UNITED STATES PATENT AND TRADEMARK OFFICE

| APPLICATION NO. | FILING DATE | FIRST NAMED INVENTOR | ATTORNEY DOCKET NO. | CONFIRMATION NO. |
|--|-------------|----------------------|--------------------------|------------------|
| 10/705,978 | 11/13/2003 | Jimmy Hsu | BHT-3111-373 | 6779 |

DETAILED ACTION

FIG. 3

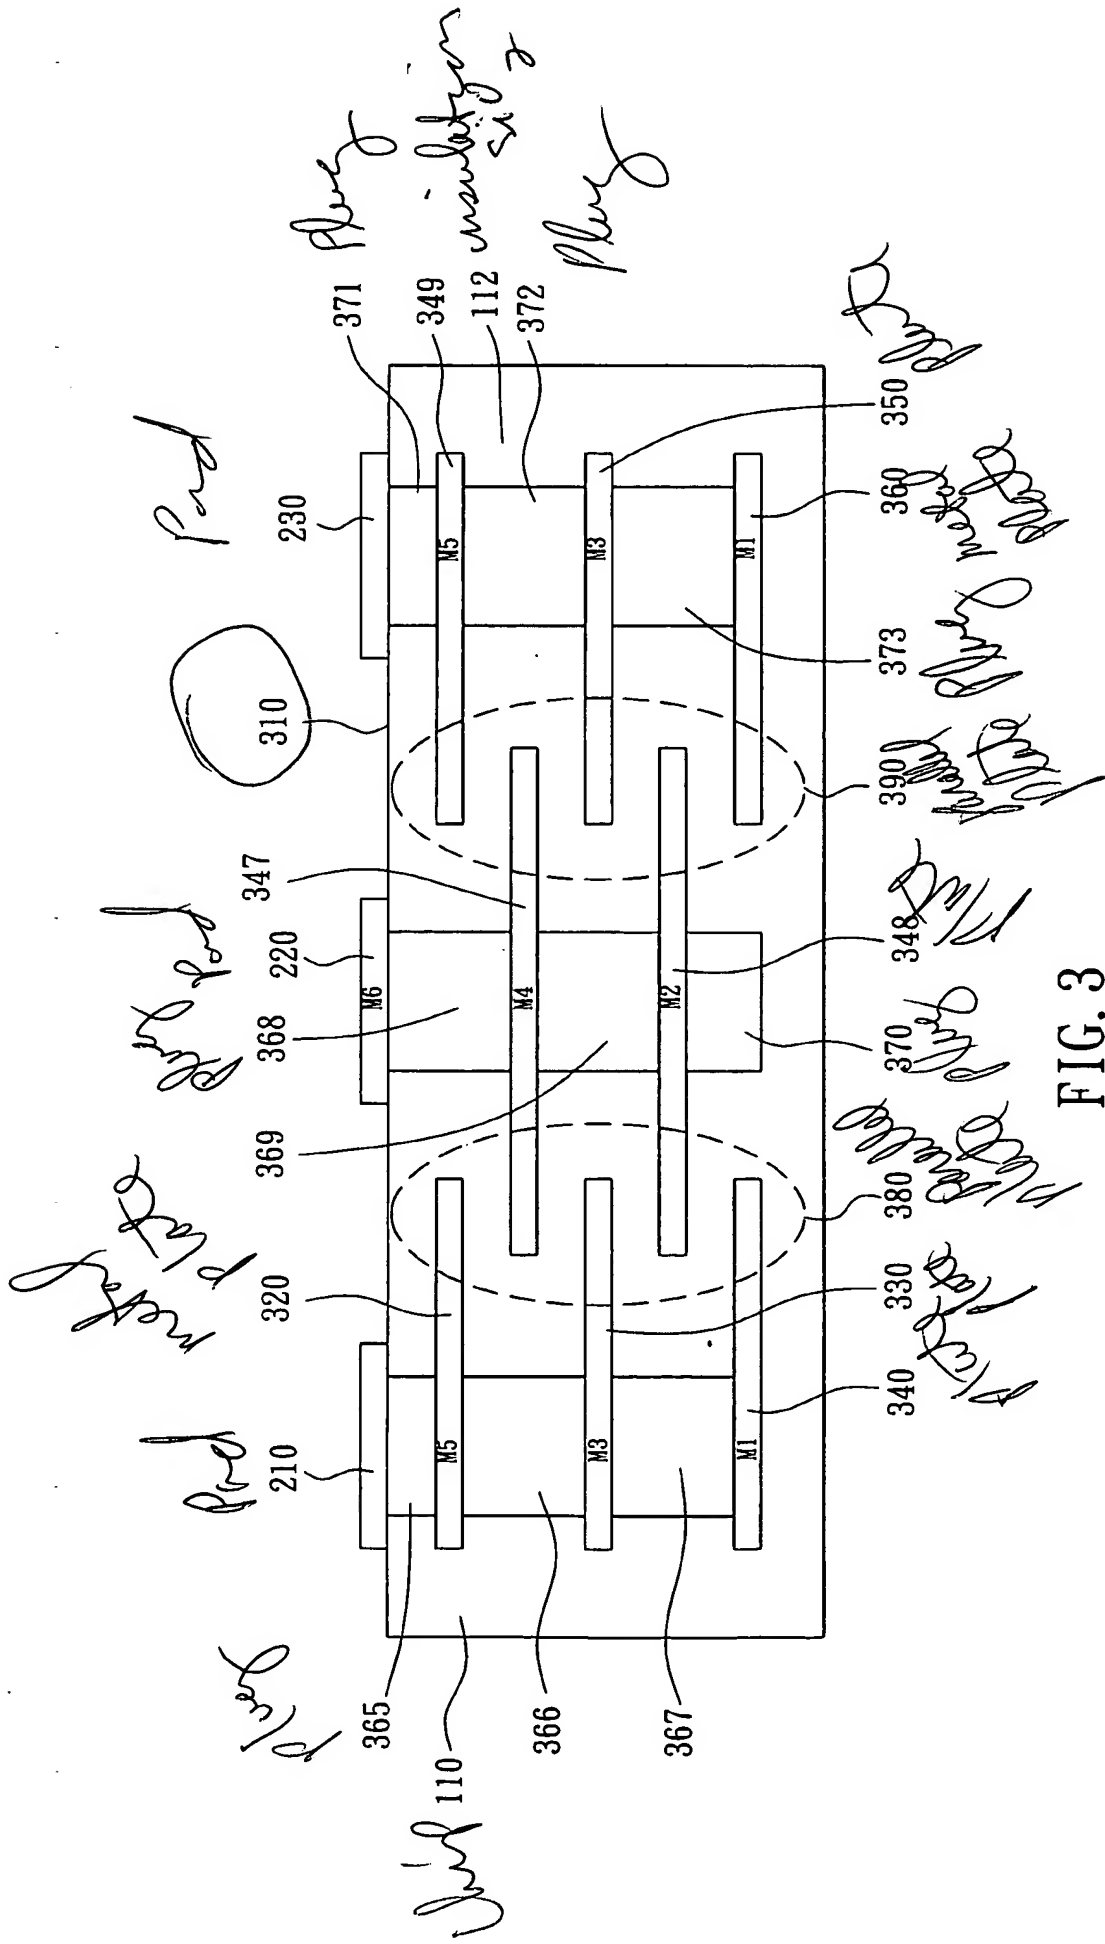
Pace (5,904,499) discloses a bonding pad structure having, as to claims 1 and 6-8, at least two bonding pads 341 (fig. 5h), wherein the pads comprise at least two metal layers 519, 518, 514 (fig. 5h) and at least two plugs (fig. 5h) that are superimposed one another; wherein at least a metal layer extends parallel and overlap other metal layer to form a resulted capacitor; wherein the metal layers or plates are positioned apart from one another. See fig. 5h and attachment.

As to claim 2, the electronic device is a chip 340. See attachment.

As to claim 4, the chip 340 comprises 6 metal layers . See attachment.

As to claim 5, the bonding pad structure has three bonding pads 341. See attachment.
